Our Ref: 133309-ADC & WSCC Response (1)
Planning Ref: AB/88/19/PL

**Re. planning application AB/88/19/PL
Ford Road, Arundel**

Appendix A contains the latest design proposals (Drawing Ref: E19-003-1000 produced by SDP Consulting Engineers) dated Feb 2020.

Appendix A - SDP Consulting Engineers Drawing Ref: E19-003-1000 (dated Feb 2020)

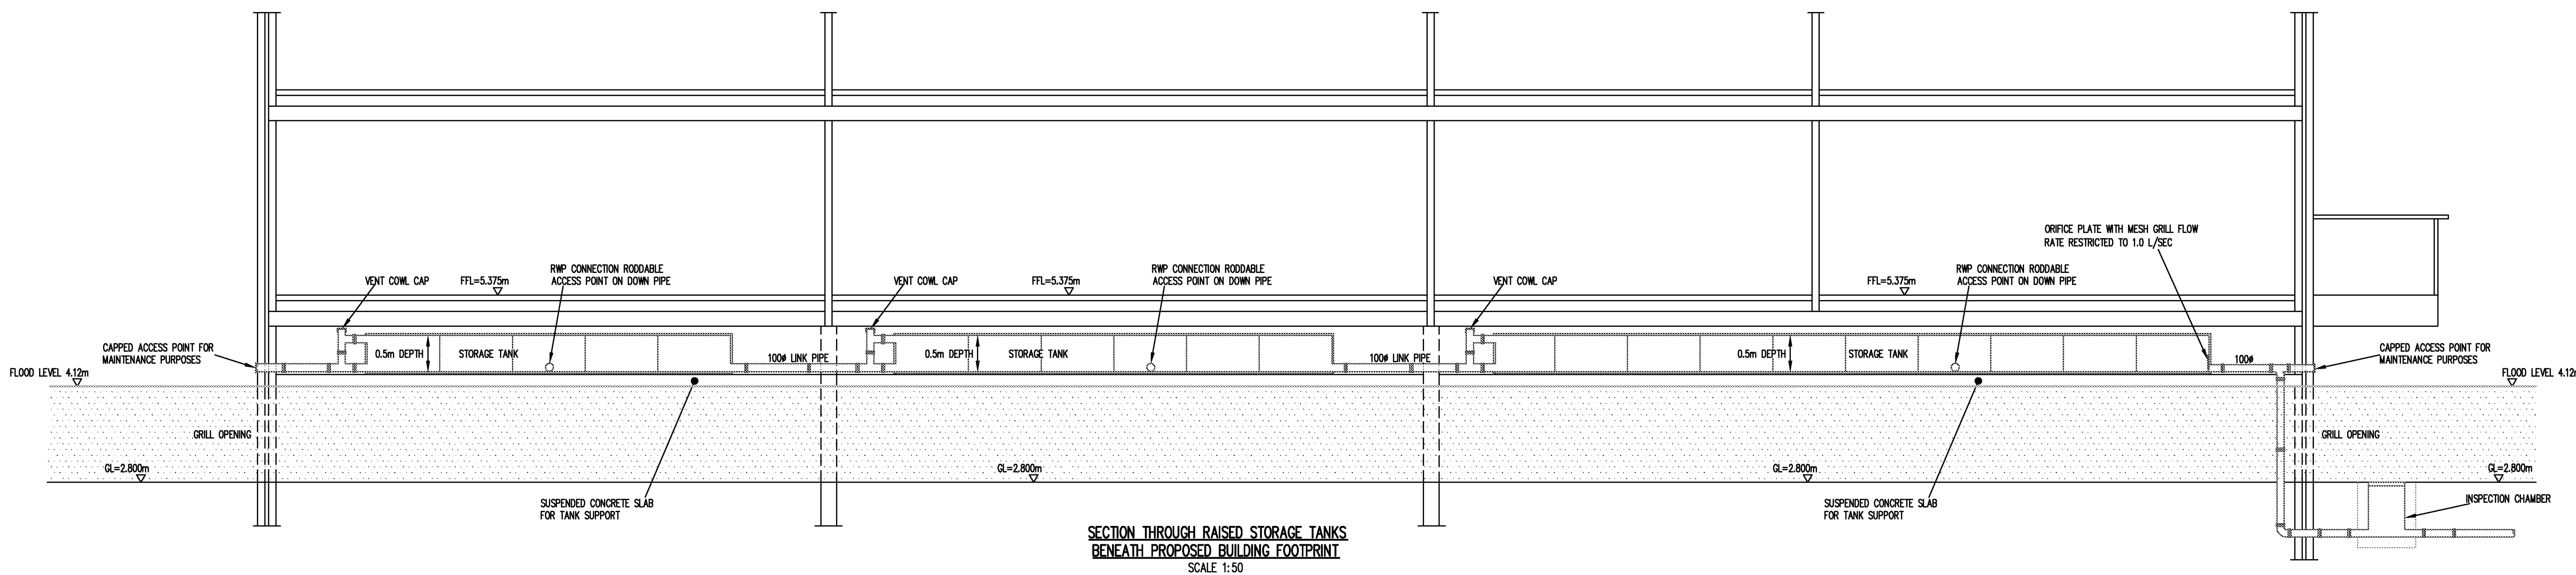
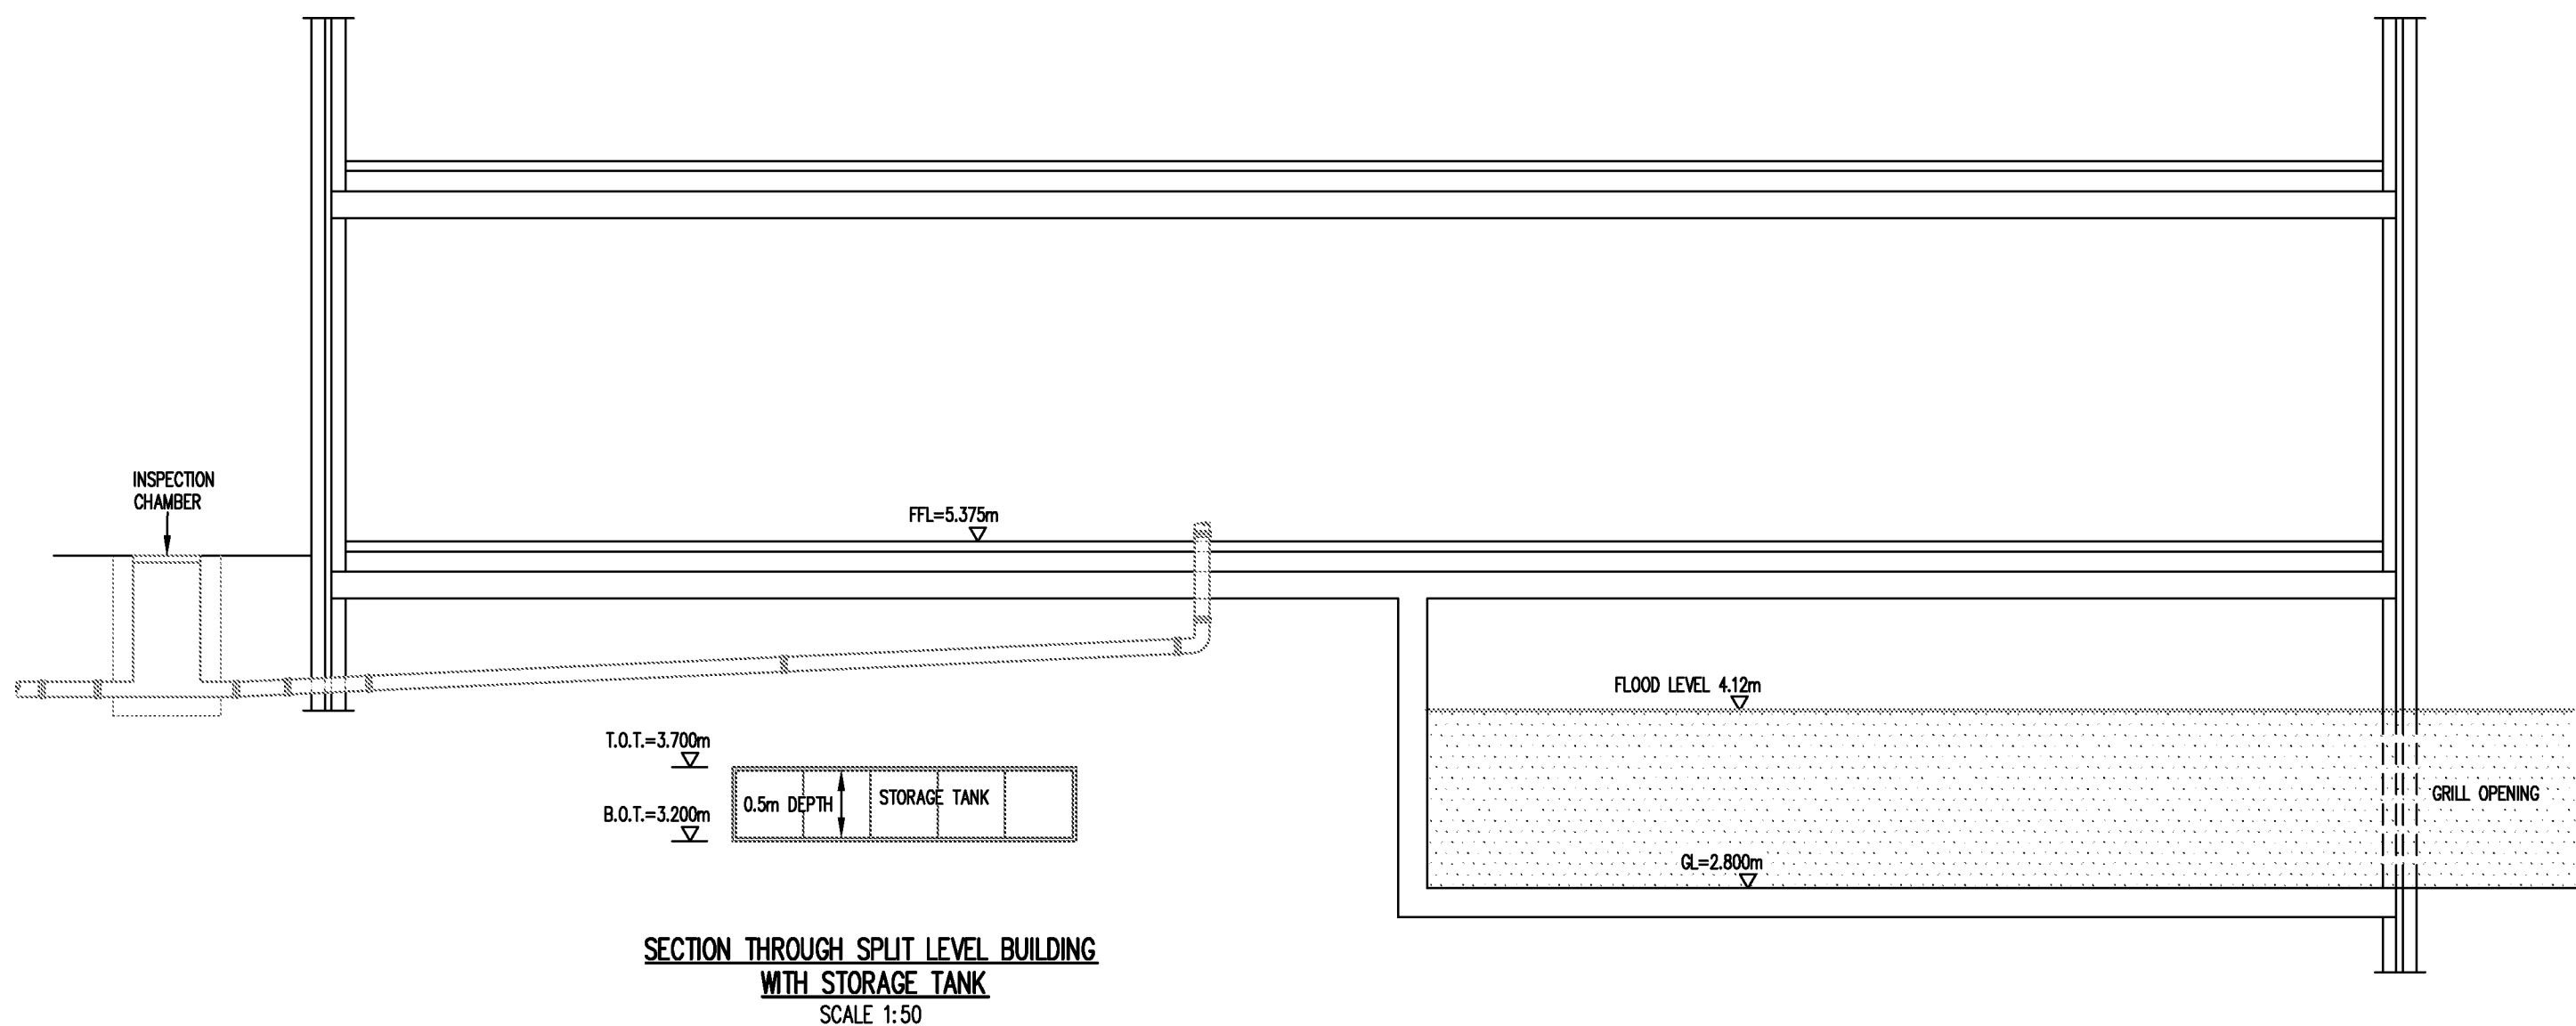
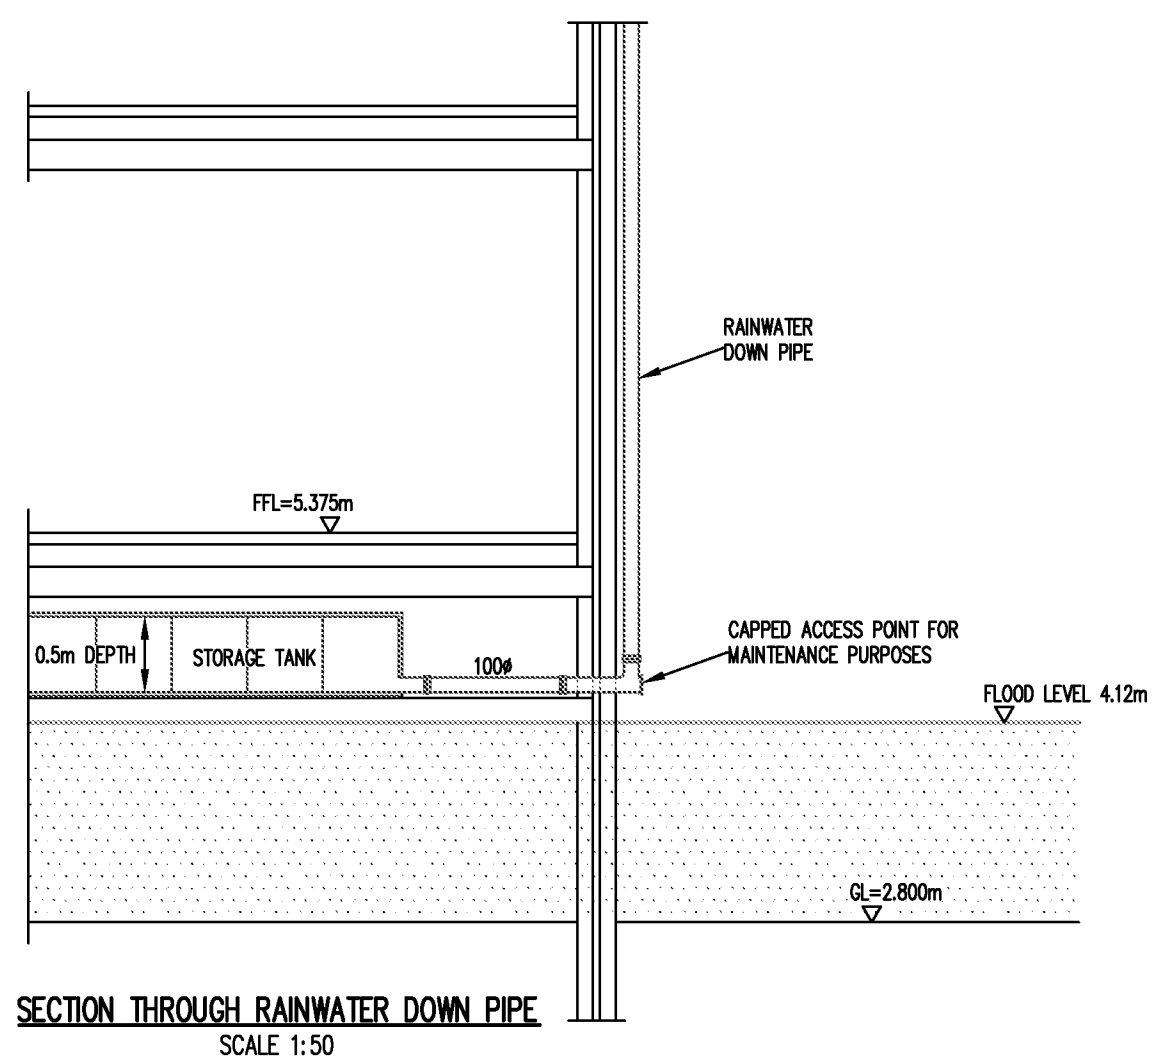
Point 4: The latest proposals from the applicants engineers are enclosed and still do not resolve all the issues in item 2 above. The current scheme involves installing storage tanks (to store roof water) just below first floor level and above the predicted 1 in 100 year (+ 105% allowance for climate change) fluvial flood level. These tanks would then discharge into a below ground drainage system that also serves ground level car parking areas (and within the fluvial flood plain). It is unclear whether the proposed system has been designed to accommodate a 1 in 100 year storm event + 40% climate change allowance or given due consideration to the impacts of tide locking downstream. Maintenance of those tanks and potential blockage issues with their restricted outlets are also considered to be operational issues. Nevertheless, the fact that the storage tanks will discharge into a below ground drainage system that would itself be submerged/full during the fluvial flood event, is not an acceptable or sustainable solution. For these reasons and those mentioned in item 2, we will maintain our objection. If conditions were applied as mentioned by my colleague, then it is very unlikely that applicant will be able to satisfy those relating to surface water disposal, since there currently appears to be no sustainable/workable solution given the site constraints.

This revised scheme shows that the surface water drainage from the new development has been split into three elements:

- a) The roof drainage from the front block of flats drains to attenuation tanks below the structure with a restricted outfall via an orifice plate of 1 litre/second (l/s). The attenuation is for a 1 in 100 year event plus 40% climate change. This storage is all outside the flood plain.

- b) The roof drainage from the rear block of flats drains to attenuation tanks suspended above voids below the structure with a restricted outfall via an orifice plate of 1l/s. The attenuation is for a 1 in 100 year event plus 40% climate change. This is all above the design flood level of 4.12m

- c) The car park for the development is all set at a level of 2.80m AOD which ensures no loss of flood plain storage (in line with EA guidance). The surface finish proposed is a permeable block paving which has 30% voided stone below and is then tanked with an impermeable membrane. This provides the treatment required in the SuDS manual. Below part of the voided stone is a tanked cellular crate storage tank which is tanked to provide attenuation for the 1 in 100 year event plus 40% climate change.

The overall surface water discharge from the site is limited to 4l/s.

- The tanks below the front block have access chambers at both ends and the tanks have a channel in the bottom to allow for low flows and jetting . This will enable the tanks to be cleaned as part of an ongoing maintenance programme.
- The tanks suspended below the rear block will be accessible from the voids below the building and have the same features as noted for the front block.
- The permeable block paving to the car park will need to be cleaned to ensure it performed correctly. The central drain through the storage crates can be accessed from each end and therefore can be jetted with silt being removed from the catch pit manholes.
